Final Modification Report																
<h1>GC0151: Grid Code Compliance with Fault Ride Through Requirements</h1> <p>Overview: A letter issued by the ESO on 7th May 2021 and a presentation to be made to the 27th May 2021 GCRP have identified concerns about demonstrating compliance with the Fault Ride Through Requirements in the Grid Code. This proposal seeks to apply a workable, non-discriminatory, legally compliant solution based on Good Industry Practice to address this significant operational concern in an expedited manner.</p>	<h2>Modification process & timetable</h2>

Executive summary

Figure 1 showing a theoretical worst case fault which plant has to be capable of riding through.

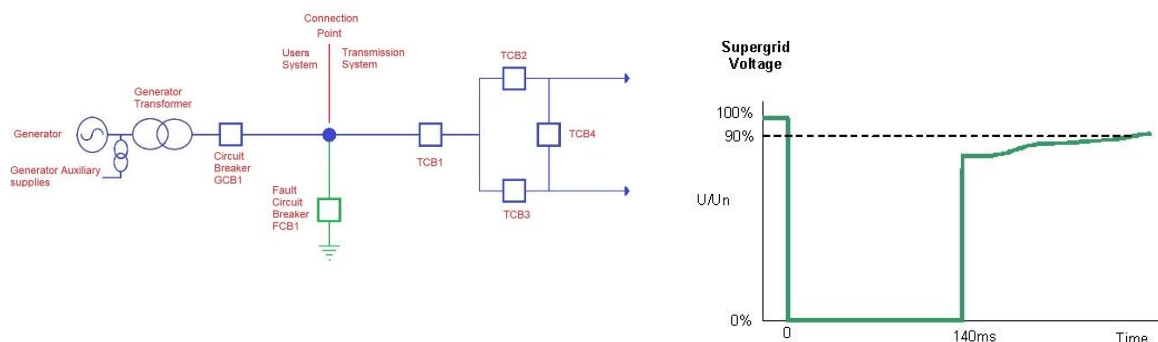
The new section CC.6.3.15(a)(i)(a) would only deal with plant capabilities by clarifying that it has to be capable of riding through the worst fault that the network could impose on the plant which is a 3-phase short circuit at the connection point which lasts for 140ms as shown in figure 1 below. To achieve this the words “be design to” will be added to section CC.6.3.15(a)(i)(a) as can be seen in the legal text contained in WAGCM2 and can be found in Annex 12.

Figure 2 showing a fault which can be cleared by transmission system breakers TCB3 & 4

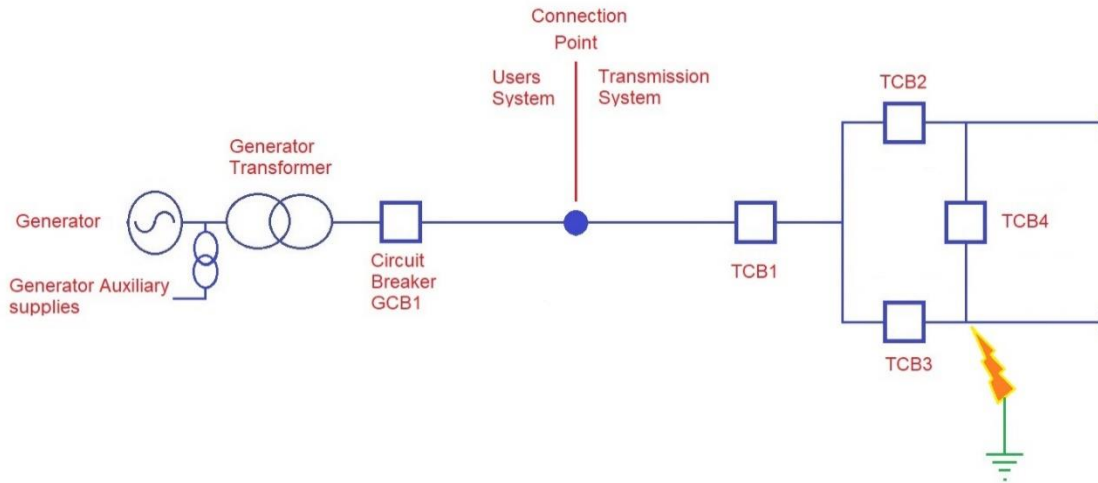
The new section CC.6.3.15(a)(i)(b) should deal with the actions to be taken in the event that a fault occurs firstly by requiring that plants ride through faults on the transmission system which can be cleared by transmission system circuit breaker as shown in Figure 2 below and by adding the following text as the introduction to the section:

- (b) Each **Generating Unit**, **DC Converter**, or **Power Park Module** and any constituent **Power Park Unit** thereof and **OTSDUW Plant and Apparatus** shall remain transiently stable and connected to the **System** without tripping of any **Generating Unit**, **DC Converter** or **Power Park Module** and / or any constituent **Power Park Unit**,

OTSDUW Plant and Apparatus, and for **Plant and Apparatus** installed on or after 1 December 2017, reactive compensation equipment, for any balanced and unbalanced fault where subjected to a voltage dip at the **Connection Point** where the voltage remains either on or within the envelope shown in figure CC.6.3.15(a)(i)(a) except where:

Figure 3 showing a fault which can only be cleared by Generator breakers GCB1

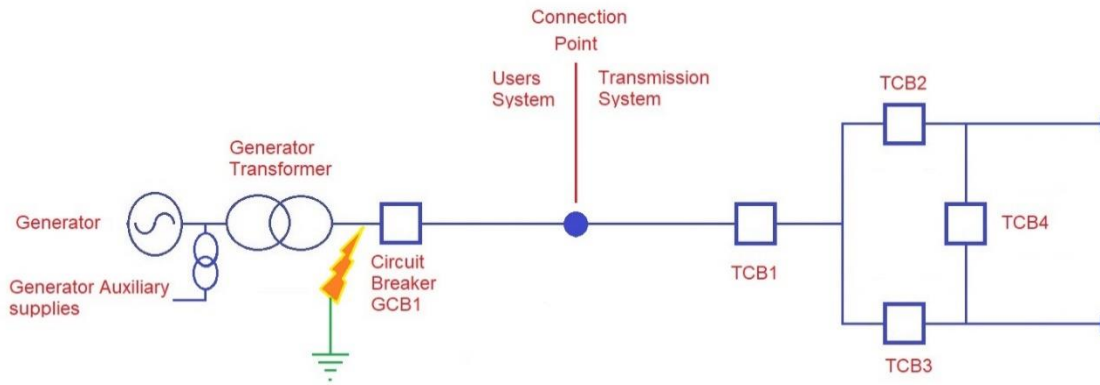
Firstly if the fault is on the Generator's equipment then the Generator shall be required to trip (normally circuit breaker GCB1 in the diagram above) to clear the fault from the transmission system as detailed in the proposed new sections CC.6.3.15(a)(ii)(b)(i) and ECC.6.3.15.8(vi)(i), as follows:-

the fault is on the **User's System**, when the **Generating Unit**, **DC Converter**, or **Power Park Module** and any constituent **Power Park Unit** thereof and **OTSDUW Plant and Apparatus** shall trip to clear the fault from the **Transmission System**. The protection schemes and settings should not jeopardise **Fault Ride Through** performance as specified in CC.6.3.15.1

Figure 4 showing a fault which can be cleared by Generator breaker GCB1 & transmission circuit breaker TCB1.

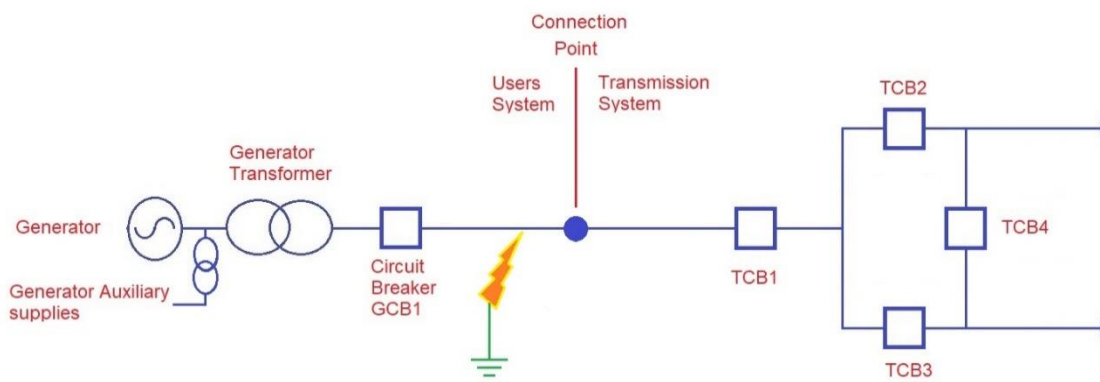
Secondly if the fault is at a location on the network that means that the fault can only be cleared by operation of both transmission and the Generator circuit breakers as shown in Figure 4, again the Generator will be permitted to trip to clear the fault as detailed in the proposed new section CC.6.3.15(a)(i)(b)(ii) and ECC.6.3.15.8(vi)(ii), as follows:-

the location of the fault means it cannot be fully cleared without tripping the of **Generating Unit, DC Converter, or Power Park Module** and any constituent **Power Park Unit** thereof and **OTSDUW Plant** shall trip as required.

Figure 5 showing a fault which can be cleared by transmission breakers TCB1,2&3, however this results in the Generator separated from the main transmission system and needs to be disconnected.

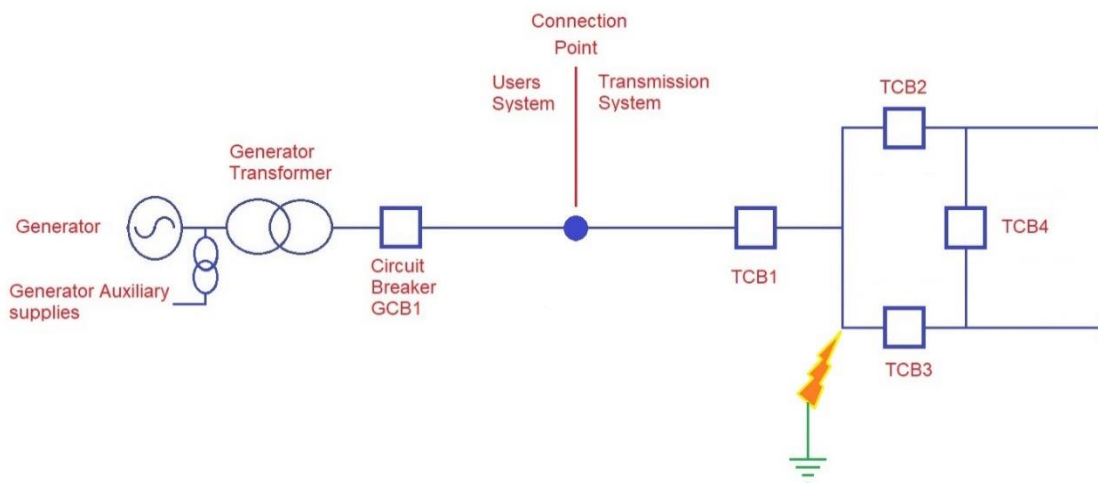
Thirdly if the fault is at a location on the network that means the Generator will become islanded by the operation of the transmission circuit breakers as shown in Figure 5 as detailed in the proposed new sections CC.6.3.15(a)(ii)(b)(iii) and ECC.6.3.15.8(vi)(iii), as follows:-

clearance of the fault results in the **Generating Unit, DC Converter, or Power Park Module** or **OTSDUW Plant** becoming islanded and disconnected from the **Total System** and not supplying **Customers** (where CC.6.3.7(c)(i) applies), then the **Generating Unit, DC Converter, or OTSDUW Plants** shall be permitted to trip as required.

Figure 7 showing the proposed reactive current injection requirements, requiring the current to always remain above the black line

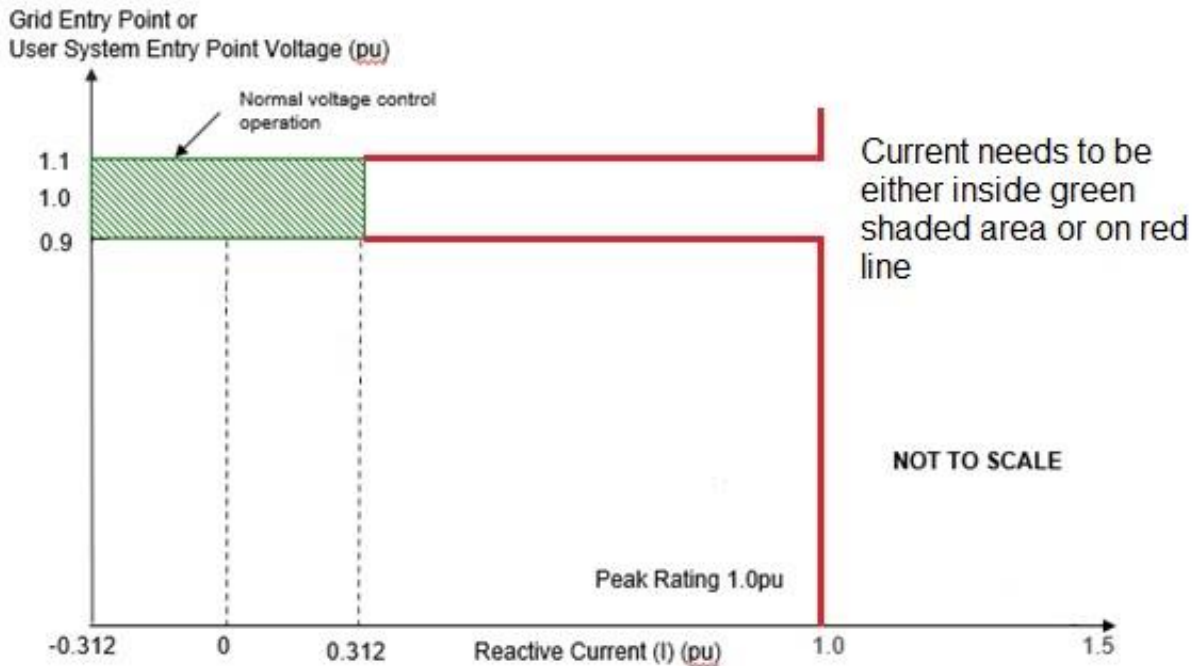
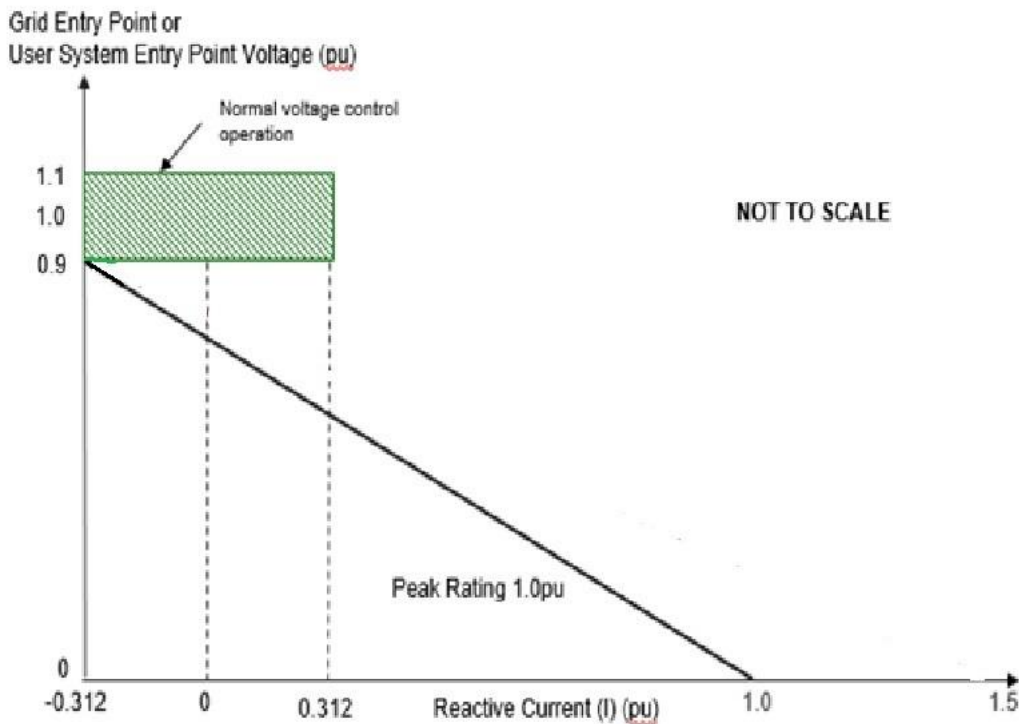
The area of the current (baseline) legal text which technically creates the biggest problem in relation to the ESO's letter of the 7th May 2021 are in sections CC.6.3.15 (a)(ii) and ECC.6.3.15.9.2.1(a)(i) which currently state "for which the voltage at the Grid Entry Point (or Interface Point in the case of OTSDUW Plant and Apparatus) is outside the limits specified in CC.6.1.4, each Generating Unit or Power Park Module or OTSDUW Plant and Apparatus shall generate maximum reactive current". If this requirement is drawn out on the figure 6 below where the reactive current and voltage must always either be within the green shaded area or on the red line.

Figure 6 shows an interpretation of the existing legal text requiring the reactive current to either be in the green box or on the red line, depending on the voltage.

This creates a particular problem in relation to the part of the ESO letter which requires Parties to confirm compliance as the Grid Code particularly FRT sections, because as drafted very few plants (if any) actually do this and this requirement has presumably drifted in as a drafting oversight relating to PPM requirements. This issue has previously been identified in the Workgroup GC0111 on Fast Fault Current injection and in the GC0137 VSM Workgroup and has been fixed for new PPMs, however currently all synchronous Generator and older PPM will technically be non-compliant with this FRT requirement as drafted. This issue was dealt with in GC0111 by adding a new figure as shown in Figure 7 and changing the text as follows.

- (iv) During the period of the fault as detailed in CC.6.3.15.1 (a) (i) for which the voltage at the **Grid Entry Point** (or **Interface Point** in the case of **OTSDUW Plant and Apparatus**) is outside the limits specified in CC.6.1.4, each **Generating Unit** or **Power Park Module** or **OTSDUW Plant and Apparatus** shall inject a reactive current above the heavy black line shown in Figure CC.6.3.15(b) without exceeding the transient rating limit of the **Generating Unit, OTSDUW Plant and Apparatus** or **Power Park Module** and / or any constituent **Power Park Unit** or reactive compensation equipment.

Figure 8 showing a typical active power response of a unit at low load to a fault

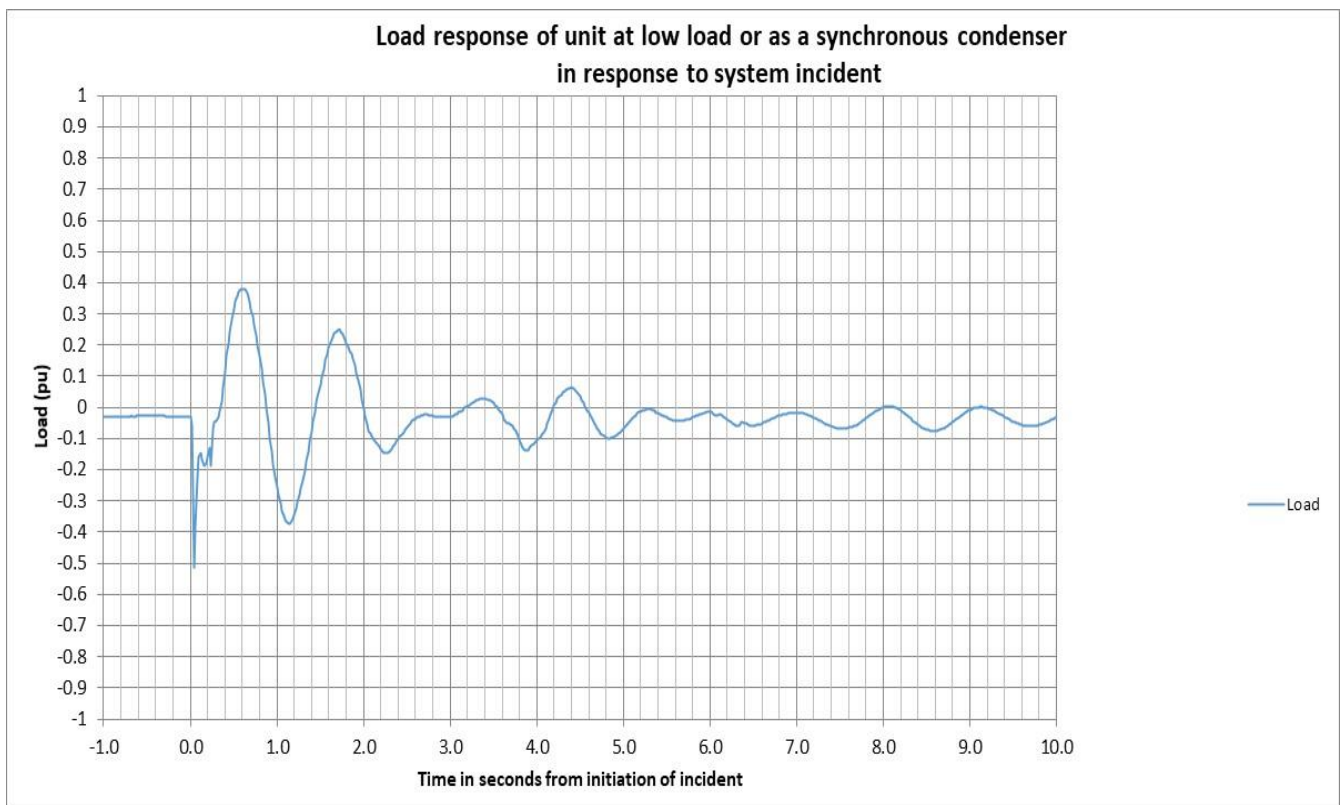
The final area of concern relating to the existing (baseline) legal text is the minimum active Power requirement after the fault has cleared. Originally as drafted the 2005 original was “(or within 0.5 seconds of restoration of the voltage at the **User System Entry Point** to 90% of nominal or greater if **Embedded**), **Active Power** output or in the case of **OTSDUW Plant and Apparatus, Active Power** transfer capability, shall be restored to the level available immediately before the fault”. Subsequently it has been realised that the real response is oscillatory and not very constant so a modification ^[ref1] has added the following words

Whilst this works in principle at higher loads, it does create an issue at lower loads if at a real event for a unit operating as a synchronous condenser in figure 8.

When considering that the initial load is 0.02 pu; 90% of this is a very small number. It could be argued that it is difficult to carry out a sensible compliance assessment at these levels and it is hence suggested that the tolerance should be changed to 10% of rated capacity as follows
